BID ADDENDUM NO. 3

Date of Addendum: January 18, 2024
Issued for Bid Date: December 18, 2022
Client Name: Eastchester Union Free School District
Project Name: 2022 Capital Bond Project, Phase 3
SED Project No.: Anne Hutchinson Elementary School: 66-03-01-03-0-001-023
Eastchester Middle / High School: 66-03-01-03-0-003-031
MEMASI Project No.: 102-2301
Contracts: Contract No. 1 – General Construction (GC)
Contract No. 2 – Mechanical Construction (MC)
Contract No. 3 – Electrical Construction (EC)
Contract No. 4 – Plumbing Construction (PC)

GENERAL NOTES, RTU FRAMING PLAN & DETAILS

MSHS S-100

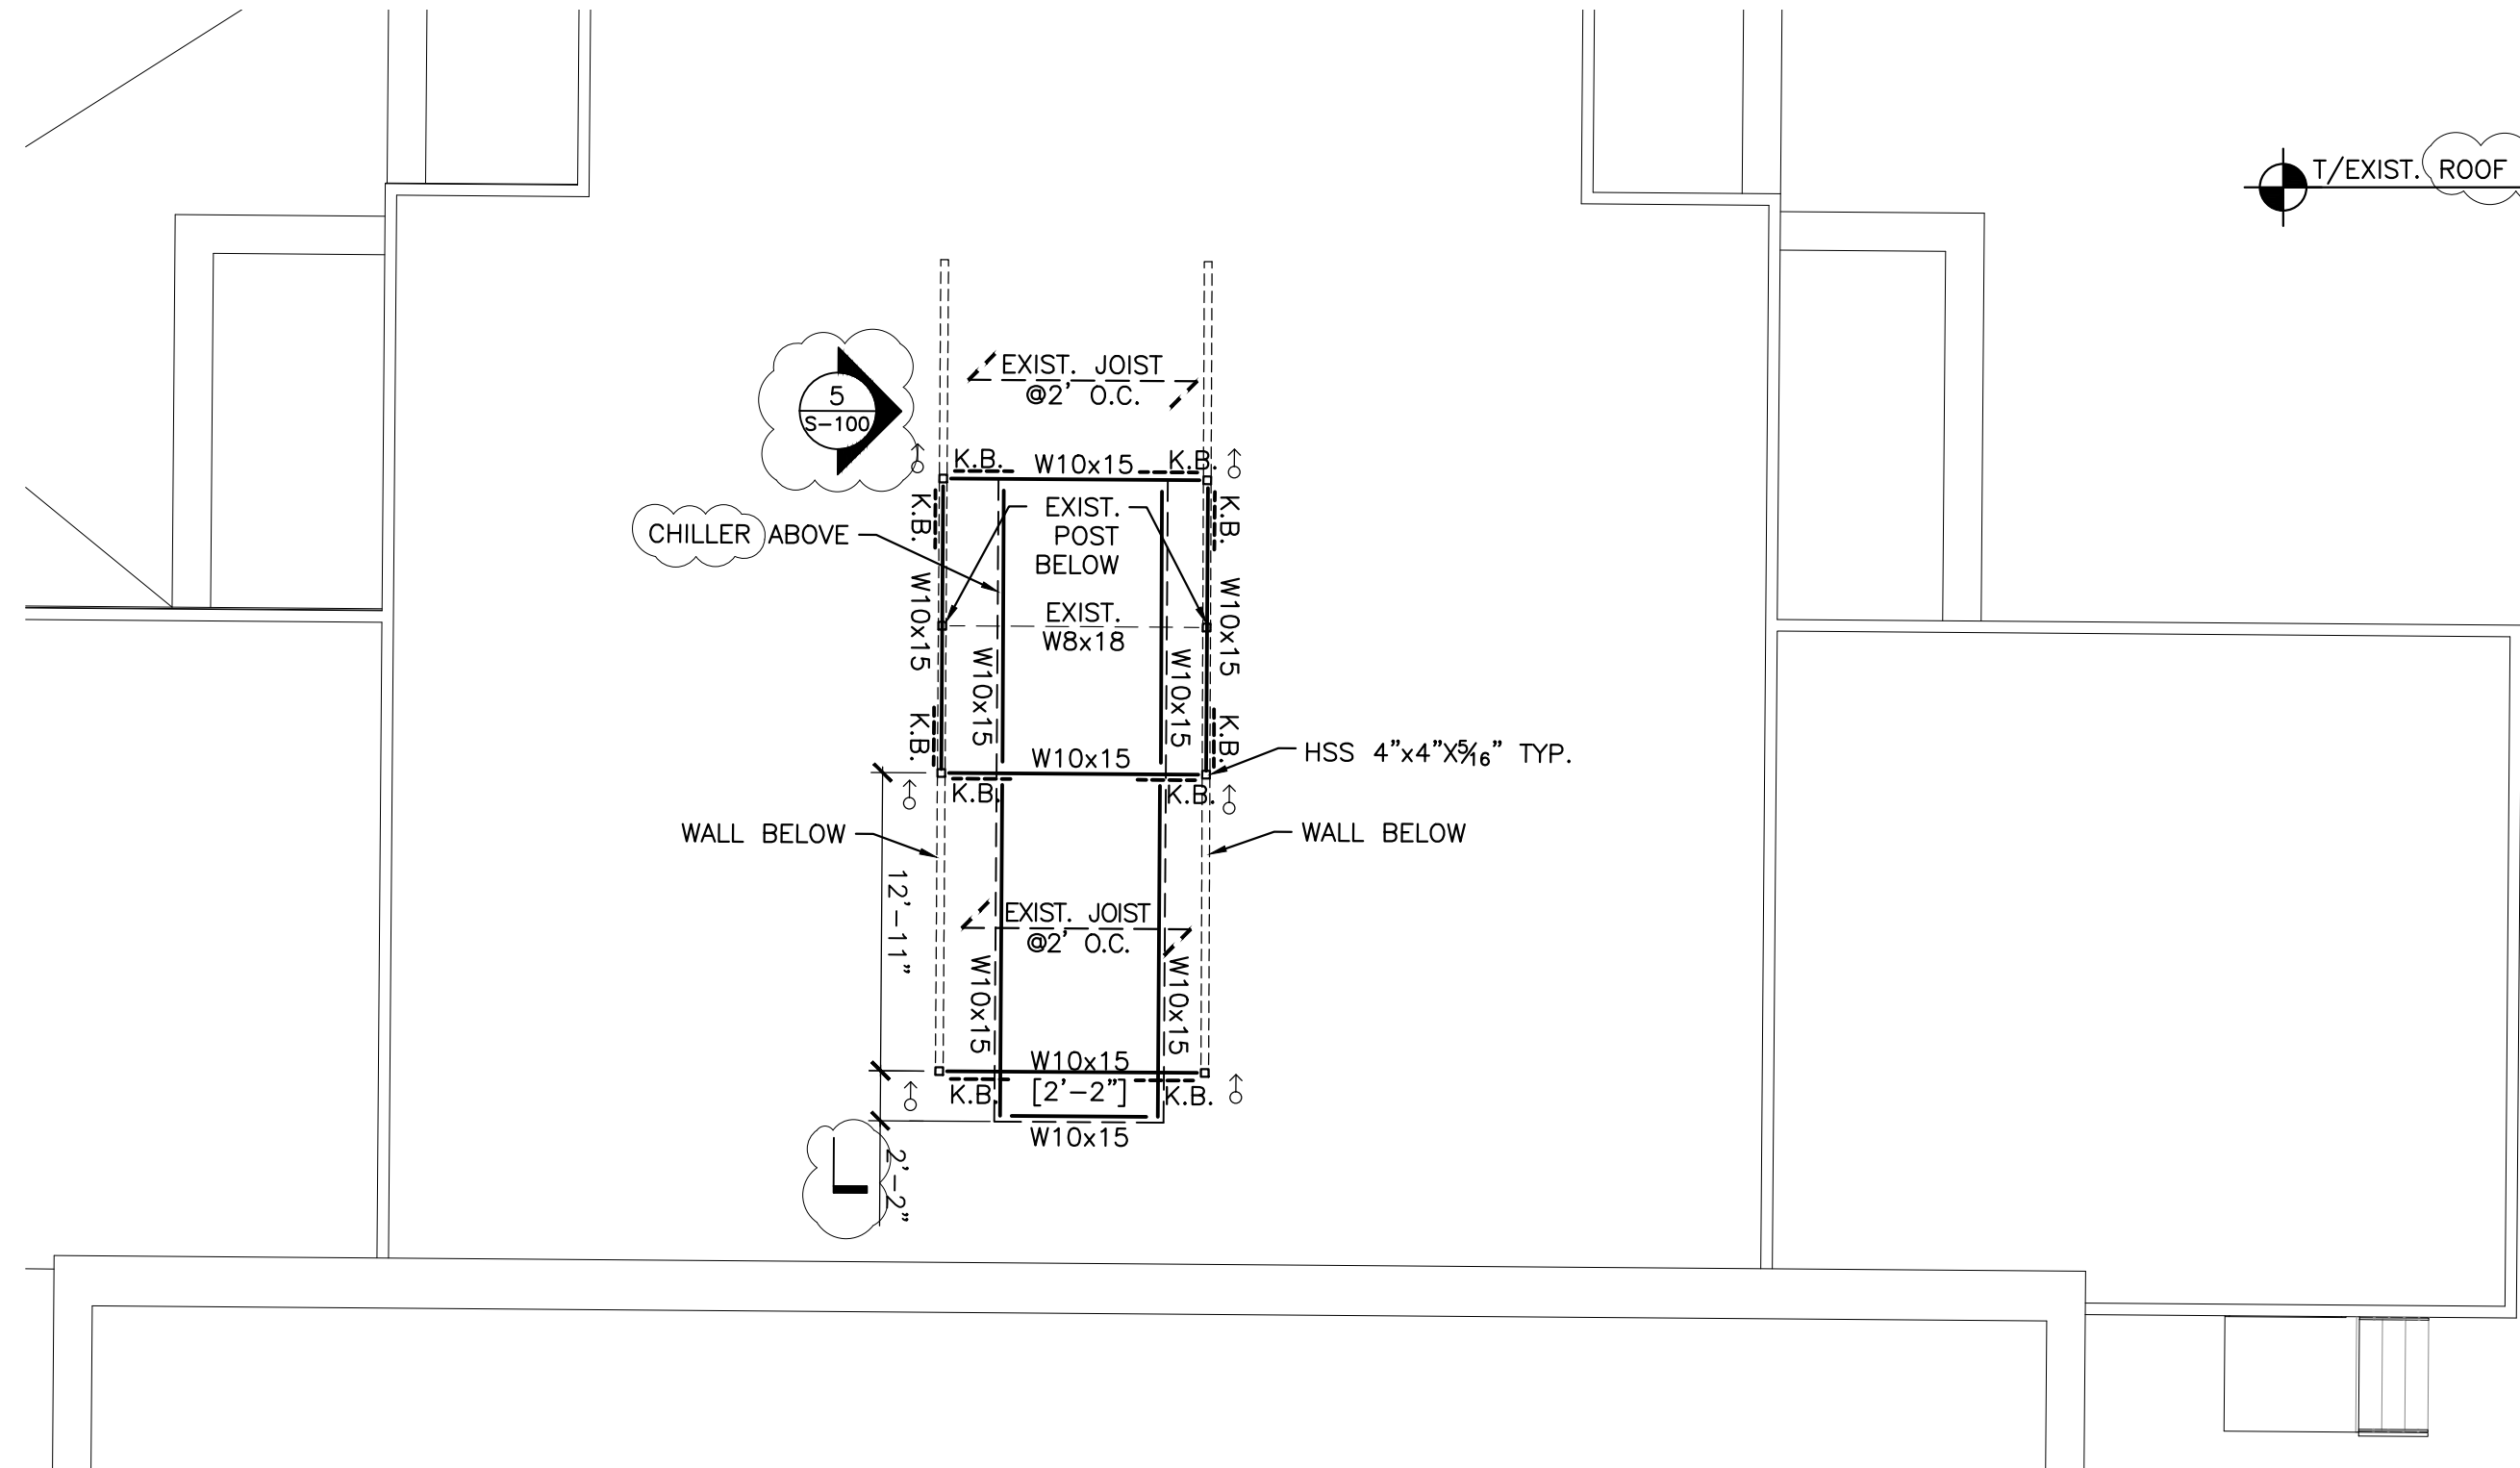
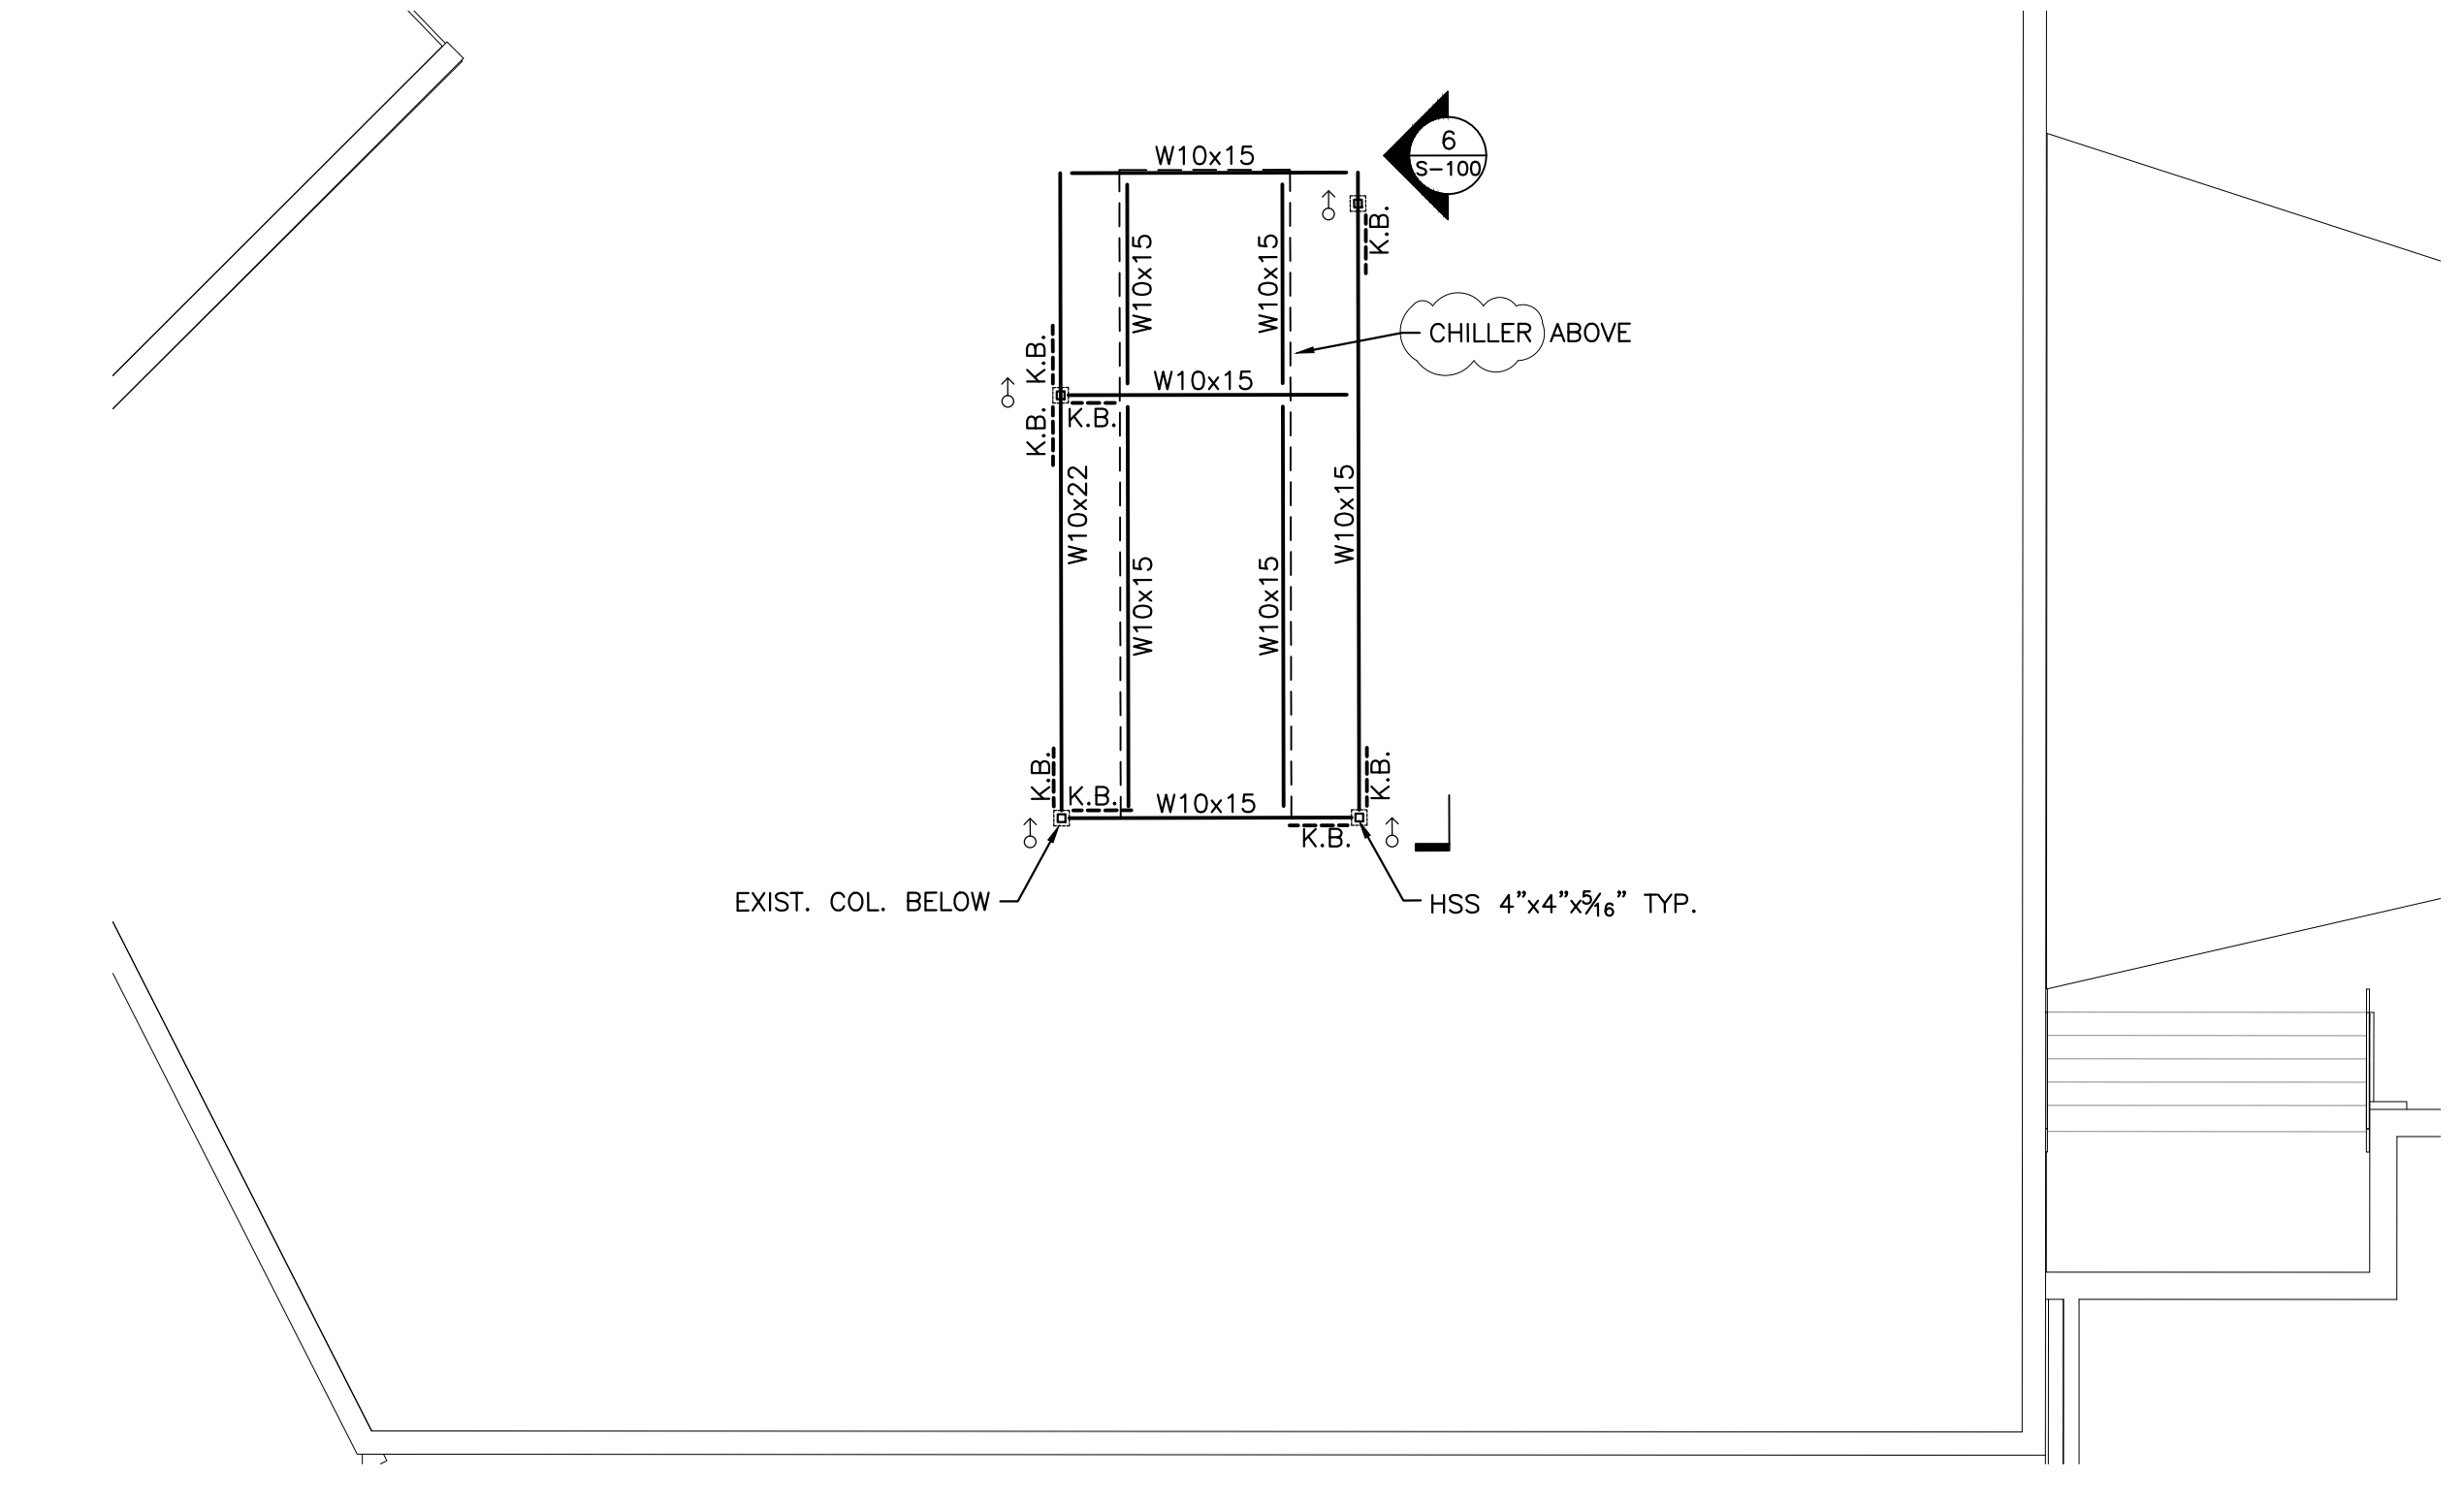
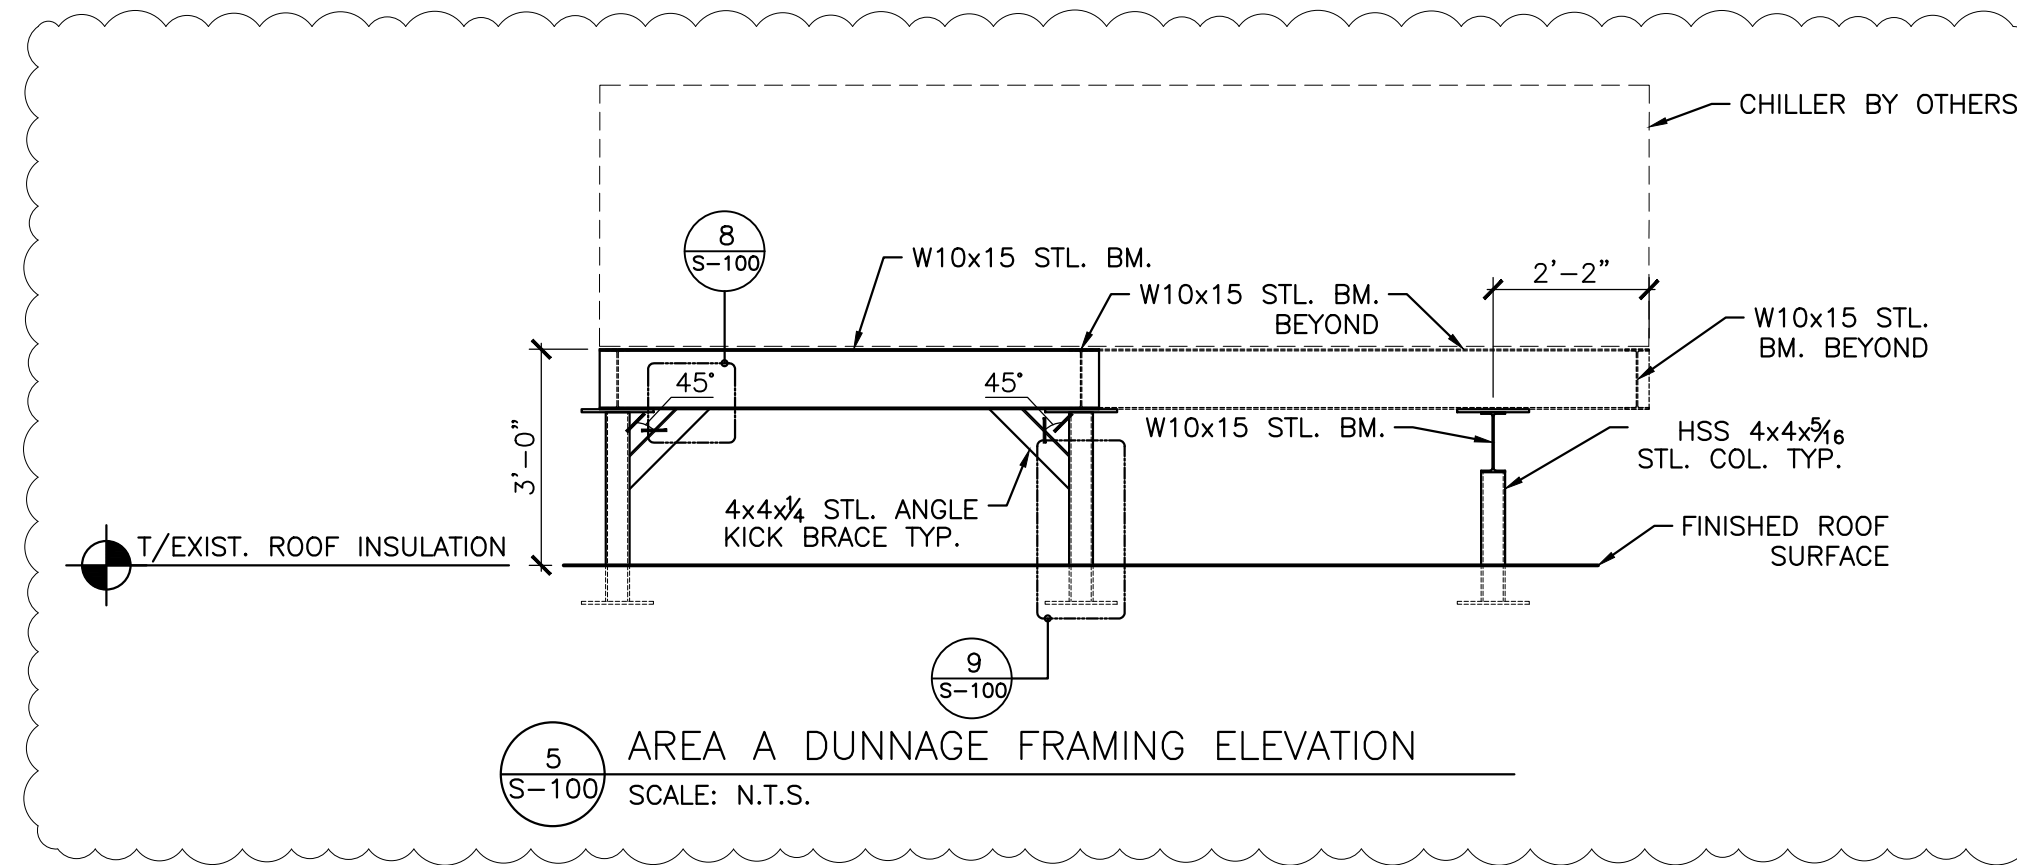
- a. Details were renumbered and page locations were corrected.
- b. For 1/S-100, Note 3 and 5 were deleted. For 2/S-100, Note 2 was deleted. For 3/S-100, notes 2,4,5, and 6 were deleted.
- c. For 1/S-100 and 2/S-100, “RTU” was changed to “CHILLER”, Notes 1 and 2 were corrected and Notes 6 and 7 were added to accommodate MEP openings.
- d. For 3/S-100, Notes 1 was corrected and Notes 3 and 4 were added to accommodate MEP

- openings.
 - e. 5/S-100 was added to clarify the dunnage design for Area A. Title for 6/S-100 was changed to distinguish from 5/S-100
 - f. 6/S-100 was edited for clarity.

- g. 9/S-100 was added to show the bearing plate to bearing wall connection for Area A dunnage that was previously not defined. Title for 7/S-100 was changed to distinguish from 9/S-100.
